USNRC APPLICATION
SUA-1341 License Amendment
Ludeman Project
Converse County, WY

June 2013

LUDEMAN SATELLITE PLANT
PLANT FACILITY LAYOUT
LUDEMAN ISR PROJECT
JOHNSON COUNTY, WY

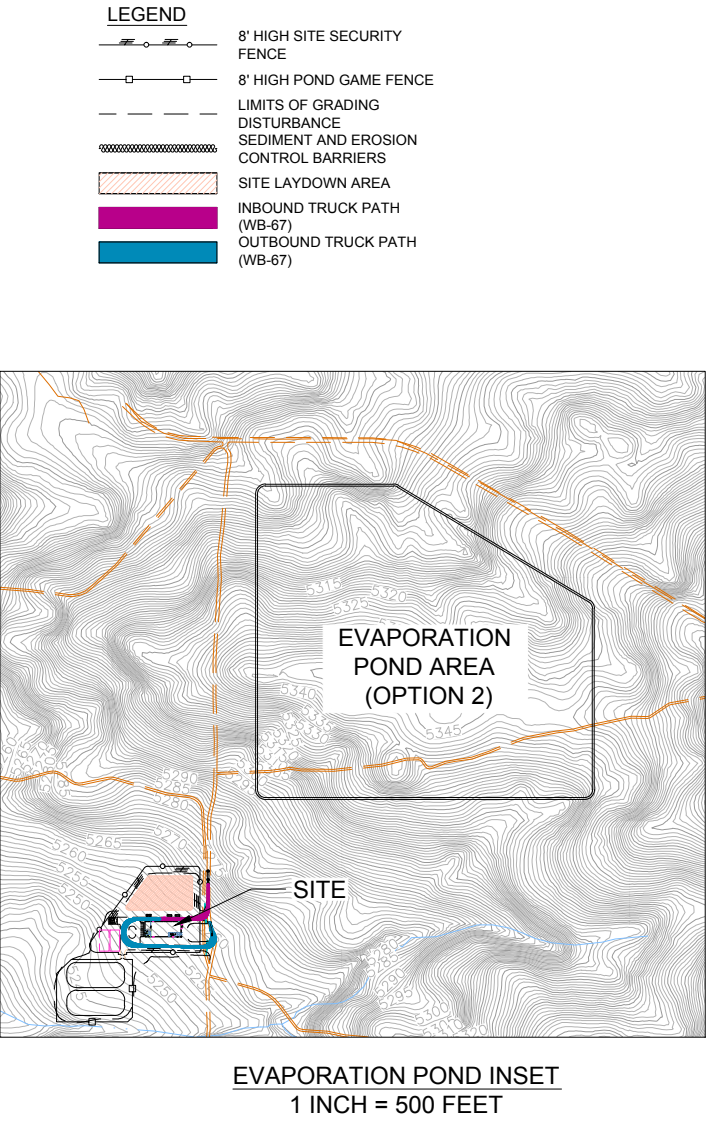
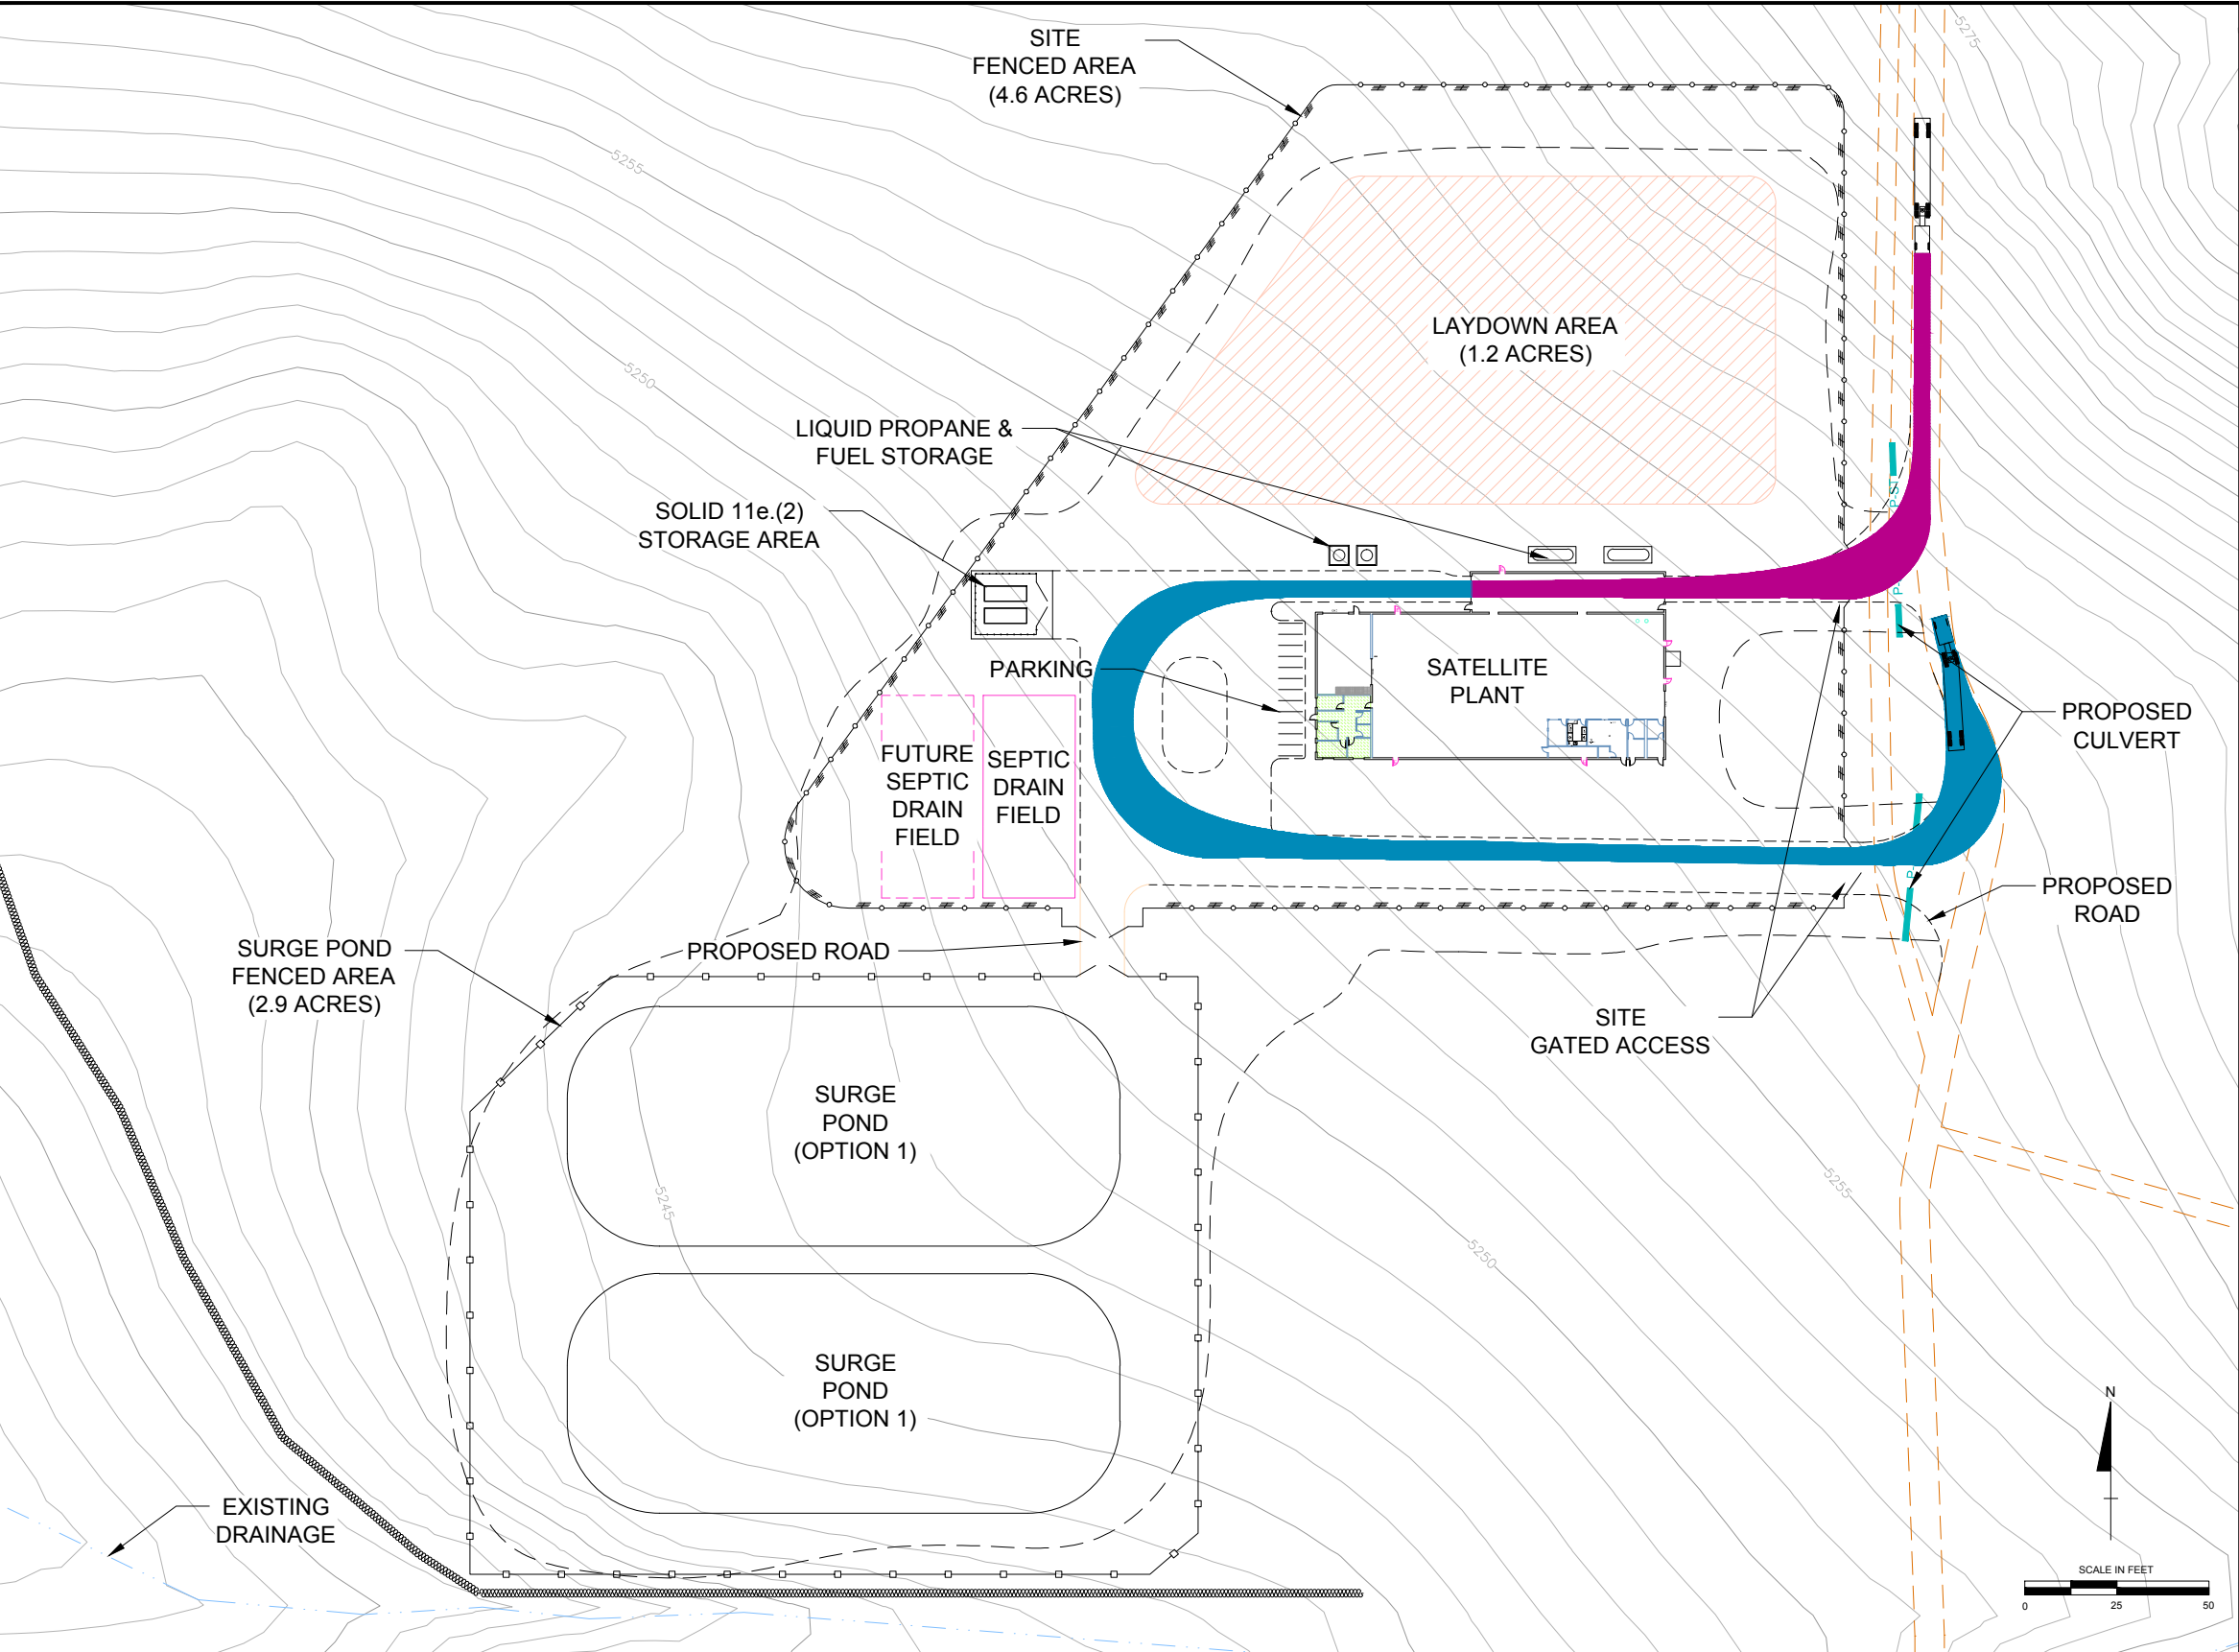
- A. Please provide additional design attributes and specifications for the structures that would be constructed at each of the Satellite areas.*
- B. Please provide information on the topographic setting where each facility and wellfield would be constructed at every Satellite area and how the design would accommodate the topography.*
- C. Please provide additional information on the final design specifications of the surface impoundments (i.e., ponds) that would be constructed at each Satellite facility, including the design for connectivity (i.e., pipelines) between the surface impoundments at the different Satellite areas and the deep-injection wells.*

Any additional available information regarding the facility design, both interior and exterior, at each Satellite area will assist the NRC during its assessment of the environmental impacts of the Proposed Action. Specifically, more detailed facility design than that shown on Figures 3-3 and 3-4 of the TR is needed for each Satellite. In addition, the number of surface impoundments at each Satellite must be clarified and the design of the impoundments finalized. Section 4.2.4.5 of the TR notes that the design presented in Addendum 4-A is preliminary and that an “inclusive surge pond design has not been completed.” In addition, Addendum 4-A of the TR notes that the second and third Satellite areas could require only one surface impoundment as the impoundments at the other Satellite areas could be used for redundancy. Final information on the overall design of Satellite areas will support the NRC’s environmental impact analysis.

Updated facility design information is provided in the revised TR Sections 3 and 4. The revised sections and associated figures provide information on current designs and geotechnical investigation for facilities within the satellite area. The proposed satellite plant layout and site facility layout is provided below.

PROJECT NO.:	CADD:	CHECKED BY:	APPROVED BY:	PLOT DATE:	FIGURE
8201.101	RRU	RMD			2
TYPICAL WELLHEAD DETAILS LUDEMAN ISR PROJECT

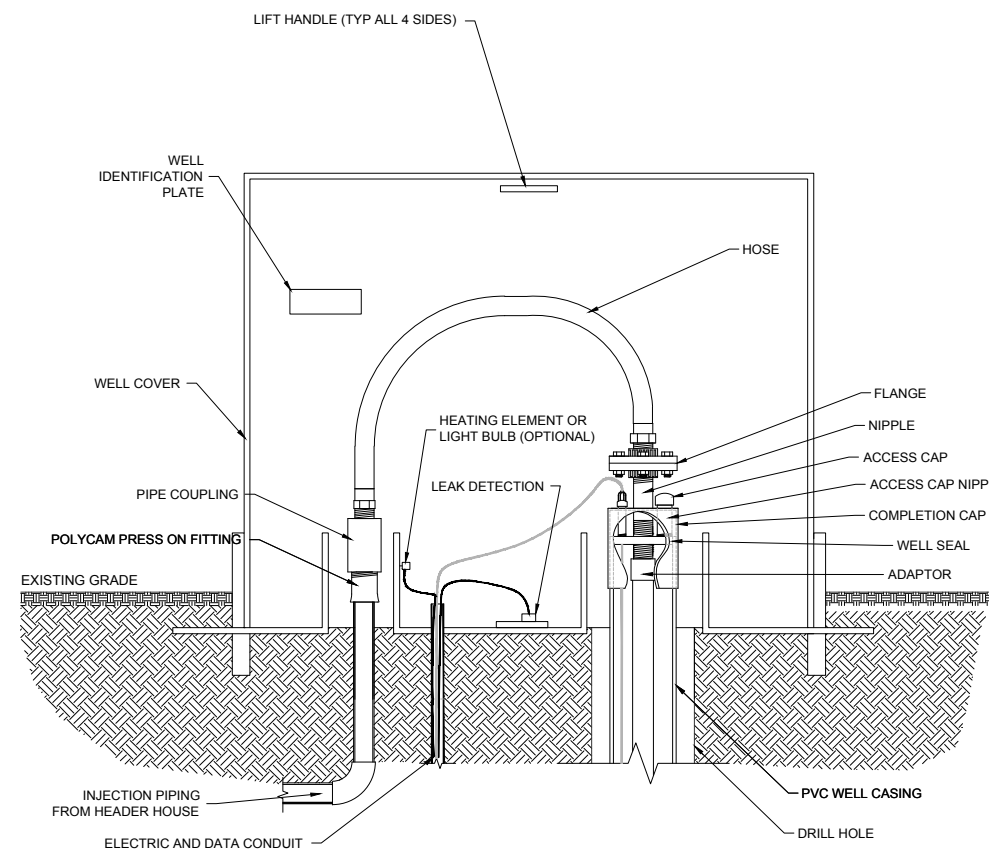
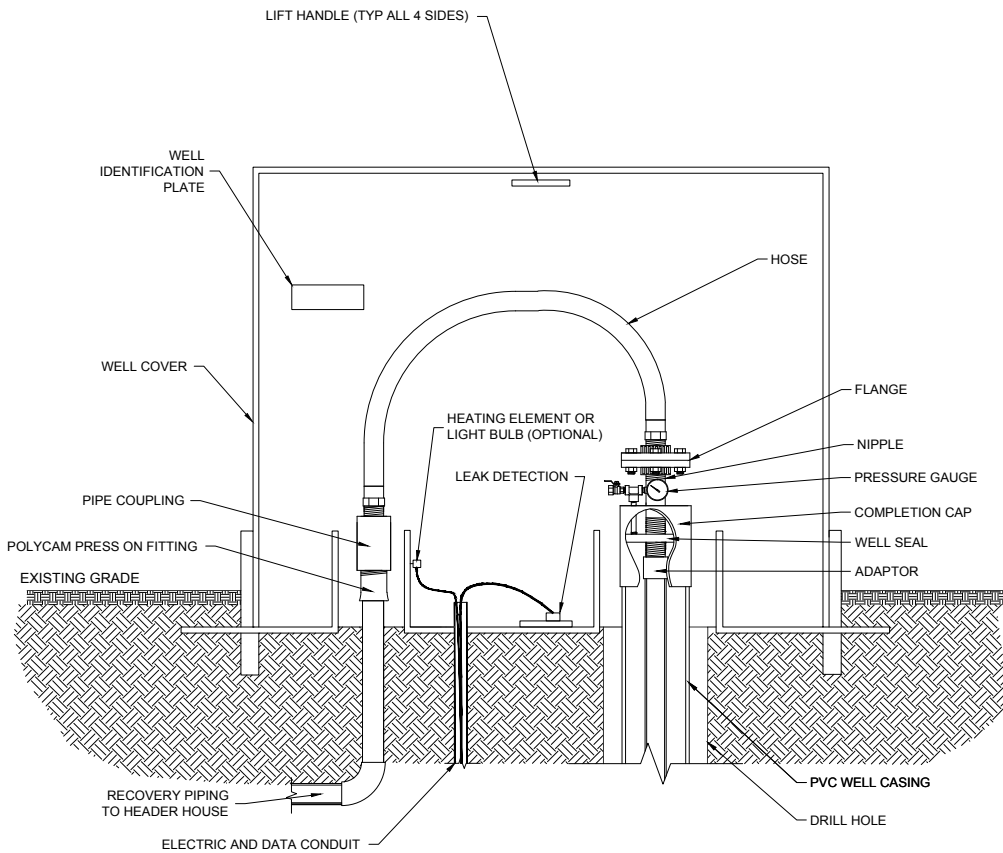
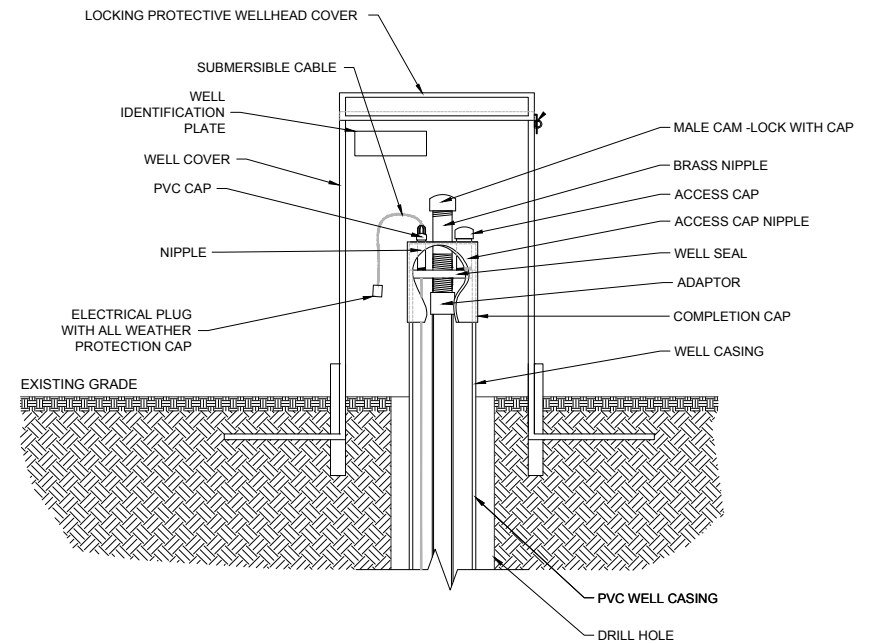
Please provide the design details of a typical header house and wellhead enclosure at a Satellite wellfield.

Uranium One is providing a schematic of the typical wellhead enclosures showing design features to support the NRC’s impact analysis. At this time Uranium One does not propose to vent the wellhead structures and TR Section 4.1.2.1 will be revised accordingly. The following figure provides wellhead design information and has been added to TR Section 3:
